SERVICE - INFO

LuK Nr: 128 0055 11 – 280mm DBVR

Bulletin 988 2000 960

CASE IH, MANITOU, VOLVO**

**Flywheel
Schwungrad
Volant-moteur
Volante-motor
Volano**

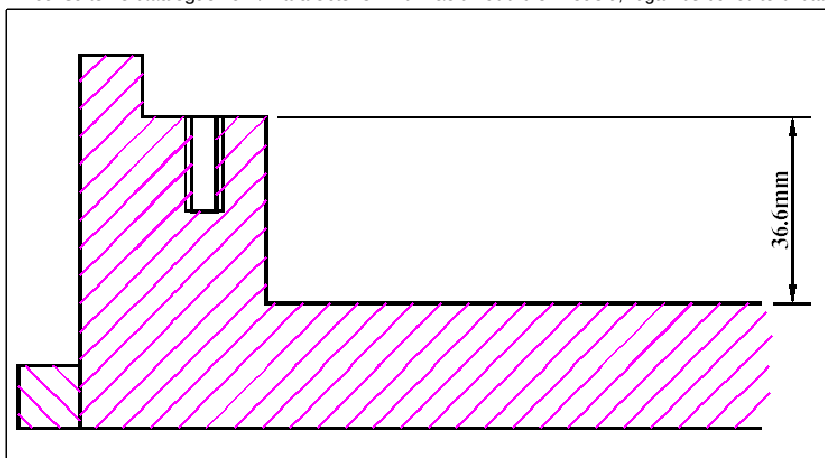
Info:	128 0055 11 replaces / ersetzt / remplace / sustituye a / sostituisce 128 0055 40 + 128 0055 41
(GB)	Please ensure that the flywheel is machined to a pot depth of 36.6mm.

Info:	Fig 2 replaces / ersetzt / remplace / sustituye a / sostituisce Fig 1
-------	---

(D)	Das Schwungrad ist auf eine Tiefe von 36.6mm auszdrehen,siehe unten.
(F)	Veuillez vous assurer que le volant-moteur est rectifié à une profondeur de 36.6mm.

(E)	Asegúrese de que el volante está mecanizado hasta una profundidad de 36.6mm.
(I)	Controllare che il volano venga rettificato a una profondità di 36.6mm.
LuK Repsets:	628 1032 07 = 128 0055 11 + 328 0175 42 + 500 1046 50 + 410 0026 00 628 1032 09 = 128 0055 11 + 328 0175 42 628 1033 07 = 128 0055 11 + 328 0175 41 + 500 1046 50 + 410 0026 00 628 1033 09 = 128 0055 11 + 328 0175 41 628 2590 07 = 128 0055 11 + 328 0175 40 + 500 1046 50 + 410 0026 00 628 2590 09 = 128 0055 11 + 328 0175 40 628 2592 07 = 128 0055 11 + 328 0175 10 + 500 1046 50 + 410 0026 00 628 2592 09 = 128 0055 11 + 328 0175 10
	128 0055 11 – 128 0055 12 + 434 0342 10

Fig 3

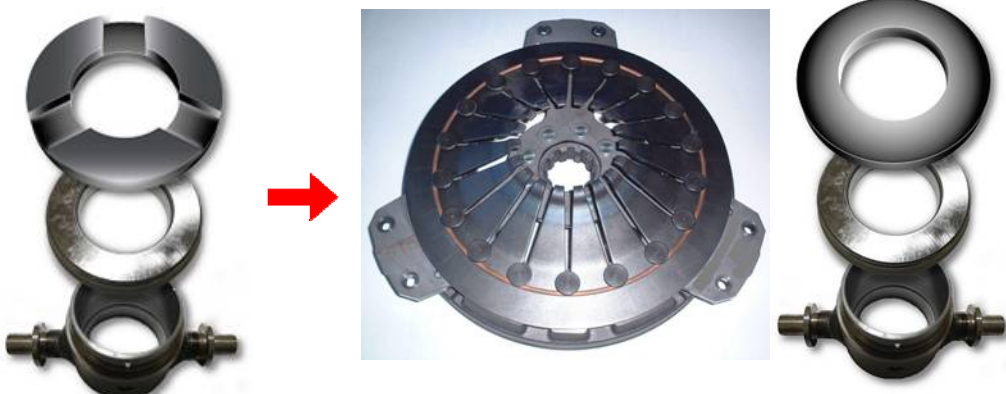
Info:	Fig 4 replaces / ersetzt / remplace / sustituye a / sostituisce Fig 3
-------	---
